In the Matter of:)	Docket No. 15-AFC-01
)	
APPLICATION FOR CERTIFICATION)	
OF THE PUENTE POWER PROJECT)

Exhibit No. 4021

Docket Number:	15-AFC-01
Project Title:	Puente Power Project
TN #:	211762
Document Title:	Oxnard General Plan Amendment - Coastal Hazards
Description:	Email from City of Oxnard and General Plan Amendment Exhibit Adopted be the Oxnard City Council on June 7, 2016, Updating Sea Level Rise Background Information and Map and Clarification of Policies Regarding Development of Large Electrical Generation Facilities.
Filer:	Jon Hilliard
Organization:	California Energy Commission
Submitter Role:	Commission Staff
Submission Date:	6/9/2016 9:29:04 AM
Docketed Date:	6/9/2016

2030 General Plan

PZ 16-620-01 [Part 4]

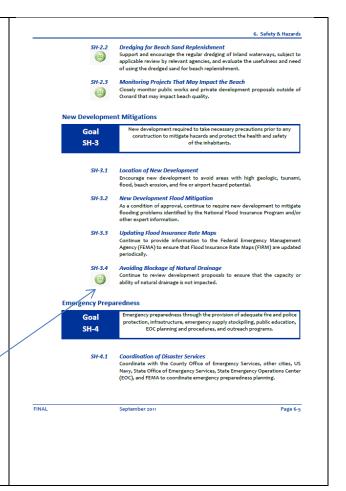
Add new Policy SH-3.5 "Development of Electricity Generating Facilities of over 50 Megawatts in Areas Subject to Coastal and Other Environmental Hazards" on page 6-5.

insert new Policy SH-3.5 after Policy SH-3.4

SH-3.5 Development of Electricity Generating Facilities of 50 Megawatts or More in Areas Subject to Coastal and Other Environmental Hazards.

The City recognizes that authority for new electricity generation facilities of 50 MW or more rests with the California Energy Commission. The City also recognizes that electricity generation facilities are especially susceptible to coastal and other hazards, particularly considering existing and expected sea-level-rise, and the resultant increased risks of tidal inundation, storm wave run-up, beach and dune erosion and retreat, and tsunami inundation. Therefore, in areas where the City has documented that the location of such facilities is threatened by seismic hazards, wildfire, flooding, or coastal hazards including tidal inundation, storm wave run-up, beach and dune erosion or retreat, and/or tsunami inundation, the following uses are prohibited: (1) the construction of new electricity generation facilities of 50 megawatts or more, (2) modifications, including alteration, replacement, or improvement of equipment that result in a 50 megawatt or more increase in the electric generation capacity of an existing generating facility, and (3) construction of any facility subject to the California Energy Commission's jurisdiction under Public Resource Code 25500.
